COMBINATION EDITION
**Wizards
Workshop**

Published by Service Admin Support

September 11, 1981
Issue 11-17

213 -6.5V SHORTED

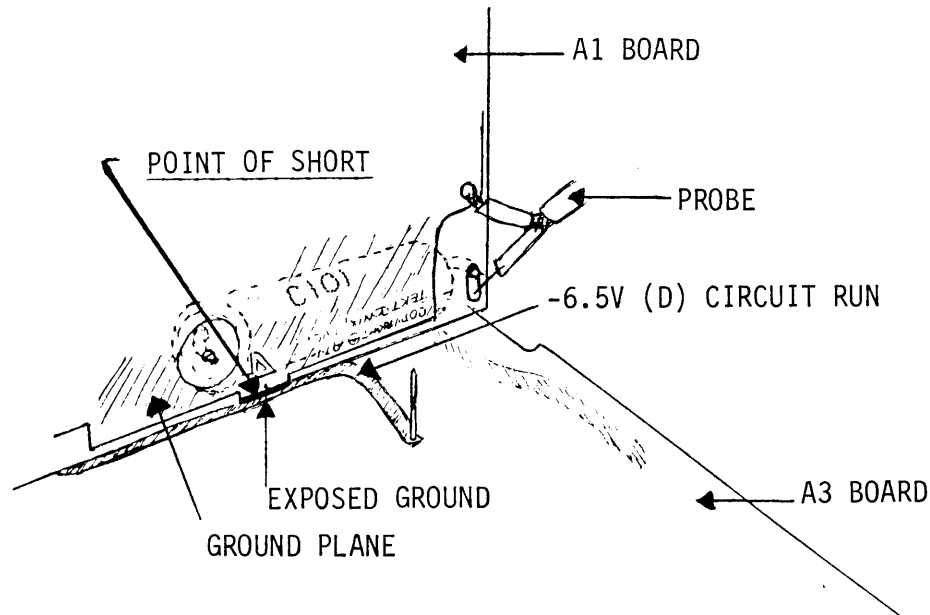
The picture below illustrates where a short can possibly develop in the -6.5v supply. Manufacturing has changed the position of the power supply run to prevent this short from happening at approximately the serial number listed above. On instruments below that number, to protect the run from shorting, use insulation film, P/N 342-0213-01, cut to cover the run and double-sided tape, P/N 006-1342-00, to hold it in place. Apply small pieces of tape so as not to cover runs.

305 H.V. MODULE WIRE LOCATION

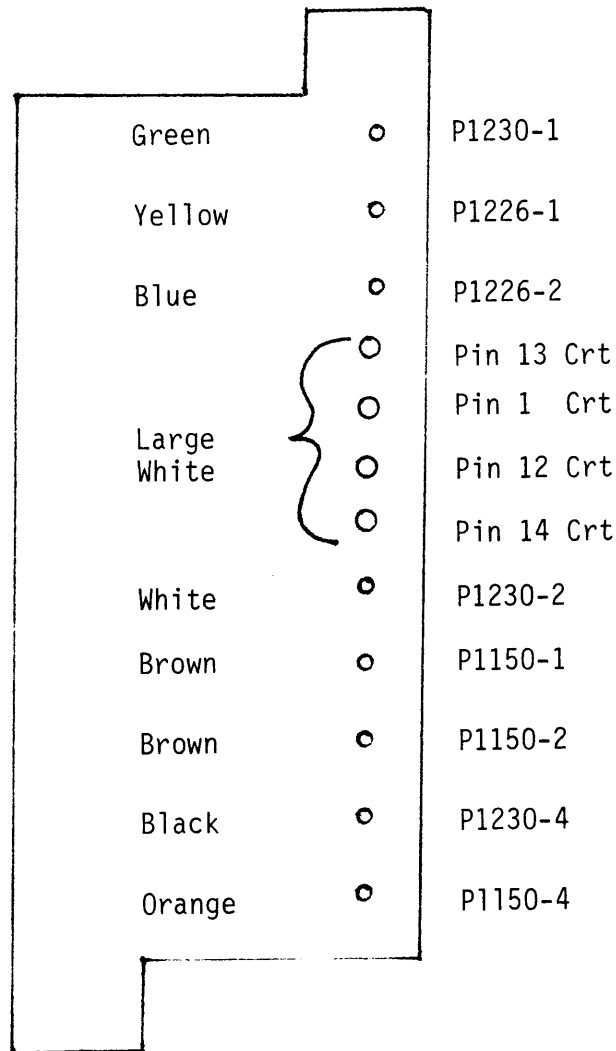
A new vendor for the H.V. module, Murata, does not number it's wires on the module as T.D.K. does. The drawing below shows the color and location of the wires.

The Murata module is black and red, whereas, the T.D.K. module is orange.

2213, 2215 LOSS OF AUTO TRIGGERS AT 58MHZ

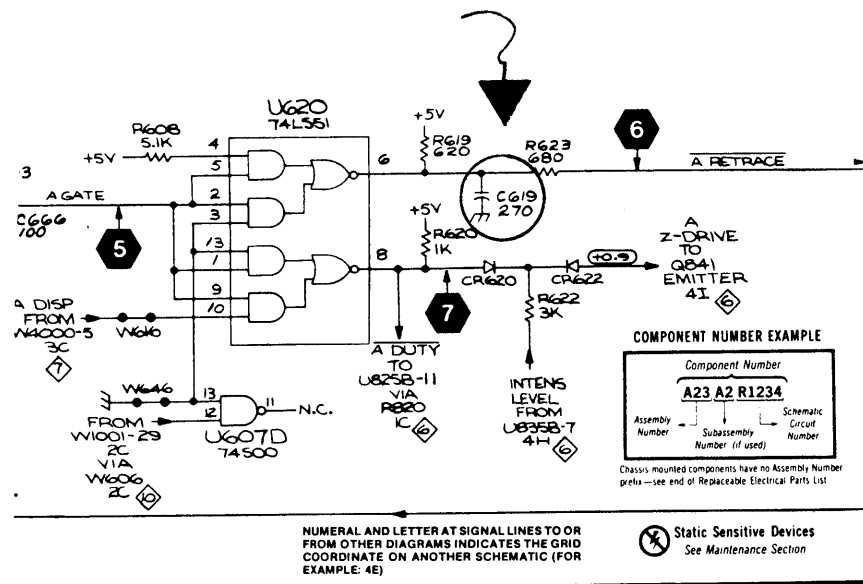
At 58MHz or greater the auto triggers may not work correctly causing loss of triggers and base line. Also, the trigger light may not function correctly. A10U640 changes to P/N 156-1195-00, which is a faster I.C. than the old part, to correct the 60MHz triggering.

Figure 1.

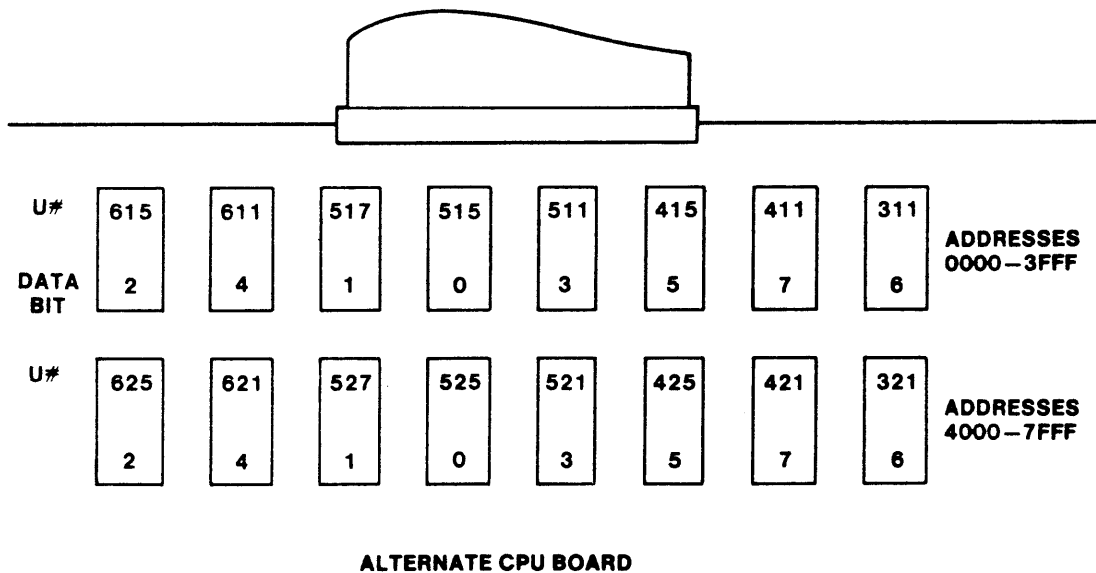
The RAMs that are being used will be 156-0968-02, which are 16Kx1 bit RAMs instead of the 156-0635-00 4Kx1 bit RAM. There will be only two RAM memory configurations for the new CPU boards. The two versions are the standard version which will be 16K bytes and the second will be the 32K bytes (Option 22). For use of the System Test Fixture the address breaks are in Figure 1.
